Fenster Farms Subdivision Phases 2
 PART OF THE SE QUARTER OF SECTION 7, T.6N., R.2W., S.1B. & M., U.S. SURVEY
 WEBER COUNTY, UTAH

Preliminary Design

Fenster Farm Subdivision Phases 2

Weber County, Utah

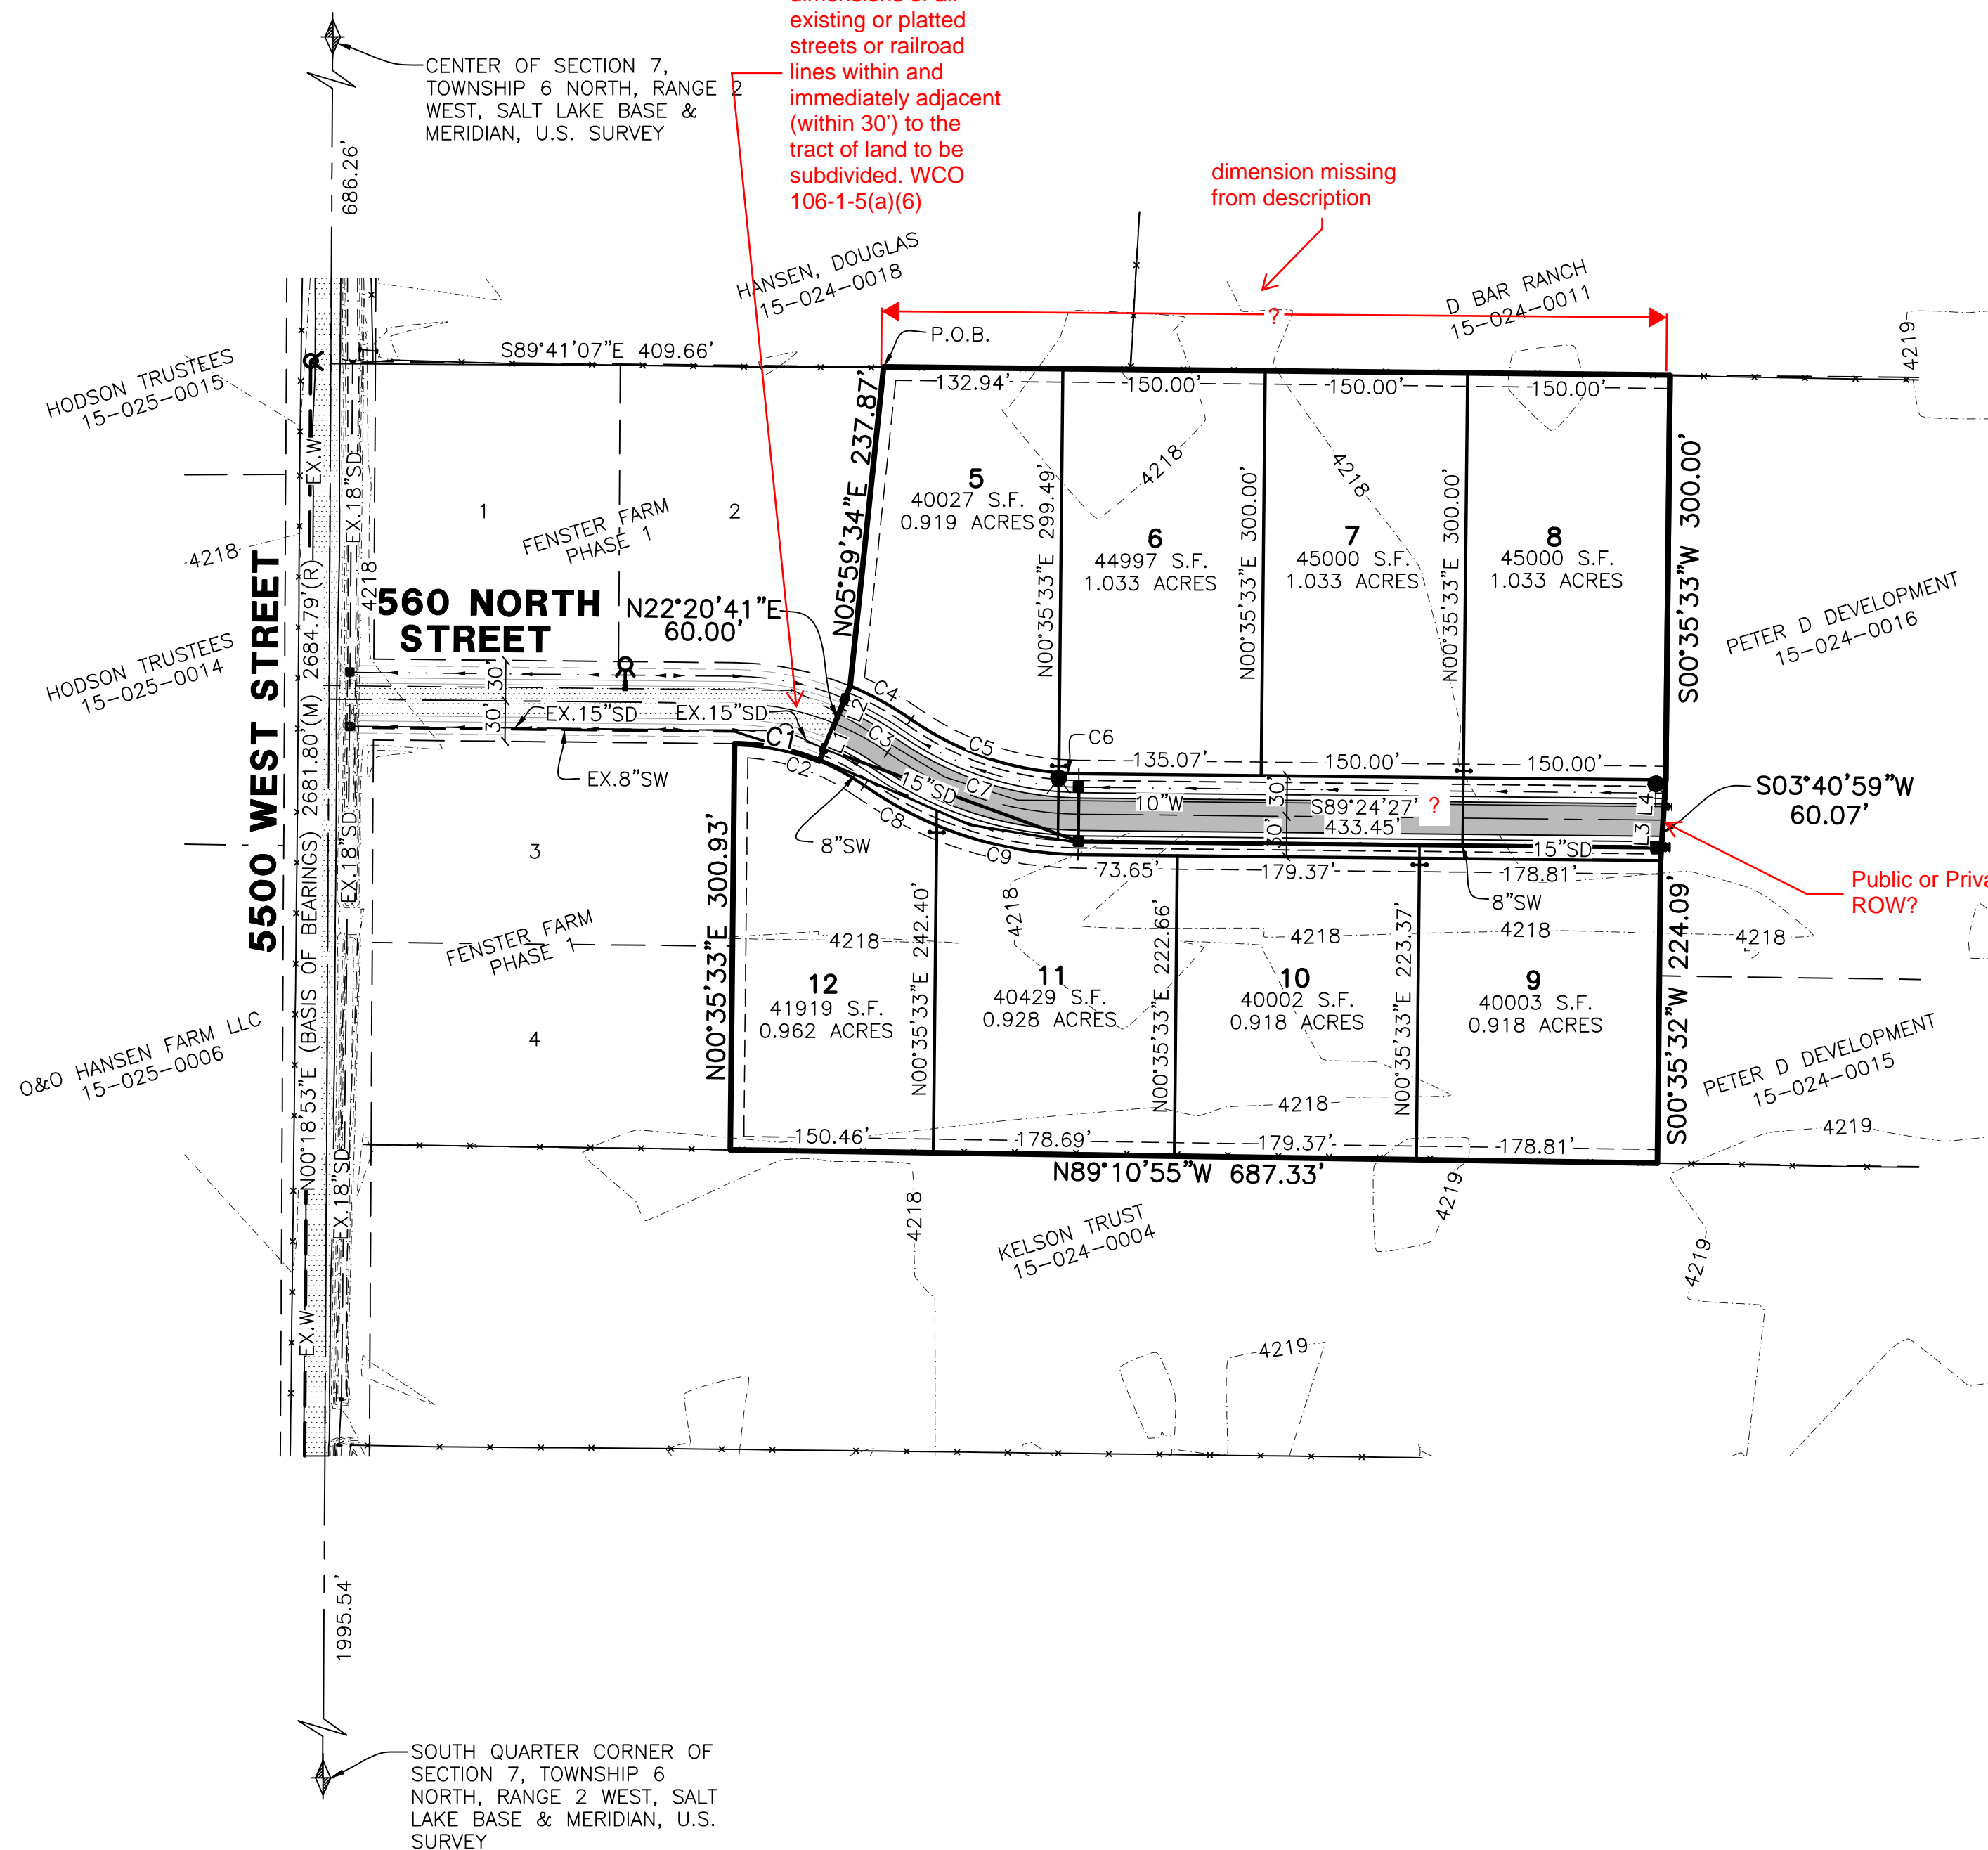
This submittal does not adequately comply with state and county requirements, please review county code Titles 45 and 106 concerning requirements for preliminary and final subdivision plats and update the plat accordingly.

Subdivision Name in bold letters at the top of the sheet. WCO 106-1-5(a)(1); WCO 106-1-8(c)(1)a

General Location of the Subdivision in bold letters at the top of the sheet. (e.g. City, County, State) WCO 106-1-5(a)(1); WCO 106-1-8(c)(1)a

The Township, range, and quarter section of the Subdivision in bold letters at the top of the sheet. WCO 106-1-5(a)(1); WCO 106-1-8(c)(1)a.; UCA 17-23-17(3)(a)

Date of the survey noted in the heading (Meaning the date, year and month the survey markers were placed). WCO 106-1-5(a)(2); WCO 106-1-8(c)(1)c.; UCA 17-23-17(3)(b)

The surveyed boundary lines of the tract to be subdivided. WCO 106-1-5(a)(4)

The existing location, widths, and other dimensions of all existing or platted streets or railroad lines within and immediately adjacent (within 30') to the tract of land to be subdivided. WCO 106-1-5(a)(6)

The existing location, widths, and other dimensions of all existing or platted buildings and structures within and immediately adjacent (within 30') to the tract of land to be subdivided. WCO 106-1-5(a)(6)

The location, widths, and other dimensions of proposed public streets, private streets, private access rights of way, or alleys with proper labeling of spaces to be dedicated to public or designated as private. WCO 106-1-5(a)(7)

Description does not close.

The existing location, widths, and other dimensions of all existing or platted buildings and structures within and immediately adjacent (within 30') to the tract of land to be subdivided. WCO 106-1-5(a)(6)
